EEE LPI Signaling

Contribution to IEEE 802.3cy

June 7, 2022

Proposed Updates for the 802.3cy EEE Text

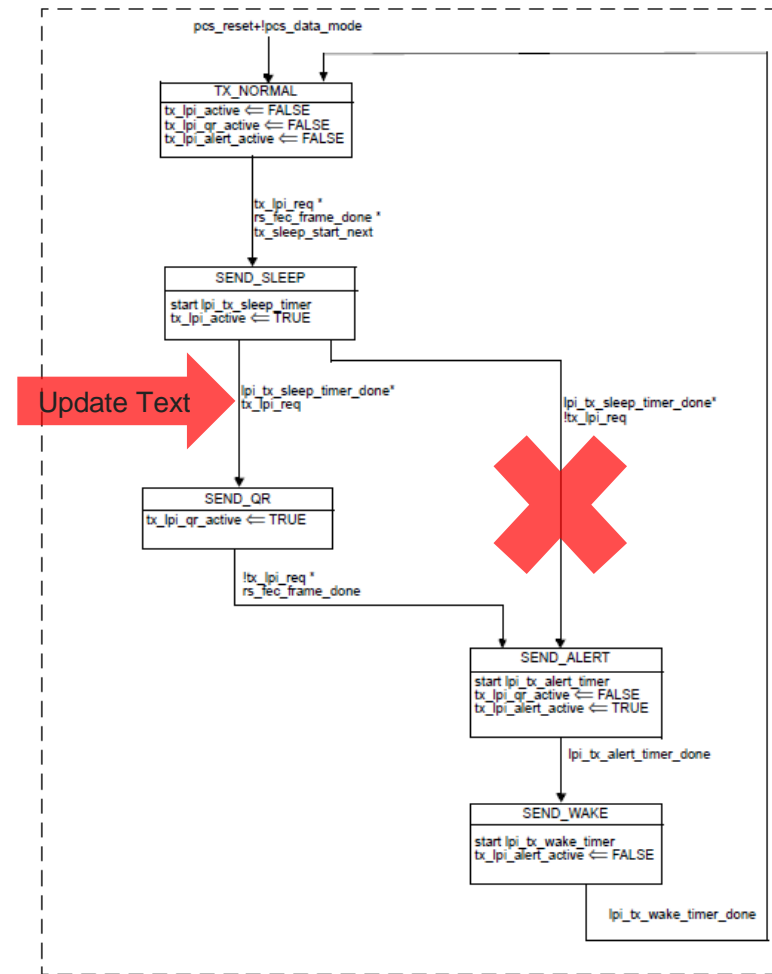
Change the text in 165.3.6.1

Refresh signaling is derived by tracking the RS-FEC frame count as shown in Figure 165–13, where:

RS-FEC frame count = floor (PFC24 / 4) mod 96.

Following the transition to PAM4, the PCS continues with the RS-FEC frame count and uses the count to generate refresh, alert, and wake control signals for the transmit functions.

Alert, a four RS-FEC frame long sequence (alert_length), shall start four frames after at the beginning of any eighth PHY frame boundary counting from the start of the QR cycle. The MASTER and SLAVE shall derive the tx_refresh_active and tx_alert_start_next signals from the transmitted PHY frames as shown in Table 165–5 and Table 165–6. When Slow Wake is active, alert can be transmitted in only a single QR cycle location, starting at frame 92.

EEE-capable PHYs shall synchronize refresh intervals during the LPI mode. A PHY in SLAVE mode is responsible for synchronizing its partial PHY frame count (PFC24) to the MASTER's PFC24 during PAM2 training. For the requirements on the SLAVE and the MASTER frame alignment, see 165.4.2.4.10.

Figure 165–13—Timing periods for LPI signals when Slow Wake not active

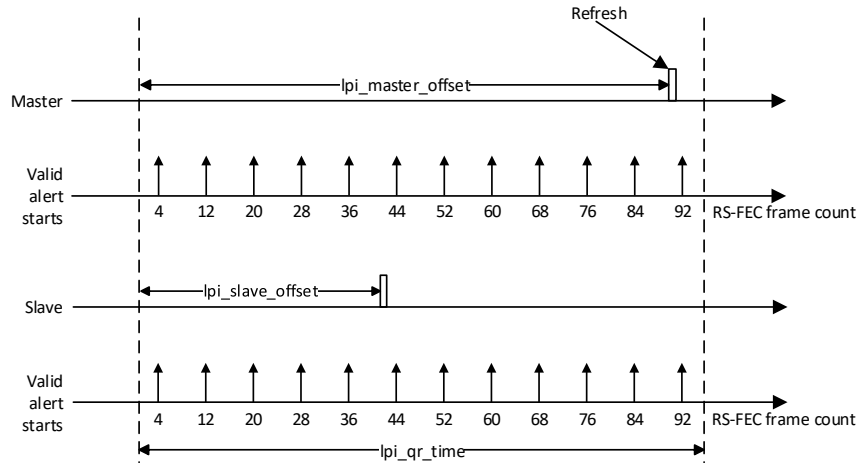
Proposed Updates for the 802.3cy EEE Text

Figure 165–20—EEE transmit state diagram

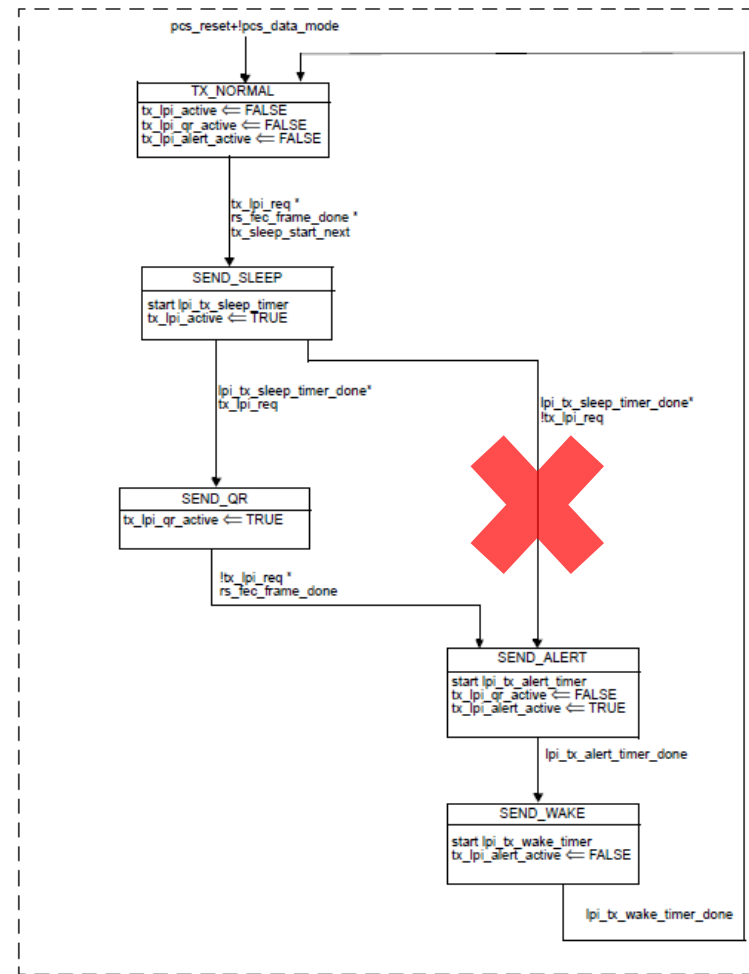
- Because of frame alignment constraints, the SEND_SLEEP state can never transition straight into SEND_ALERT
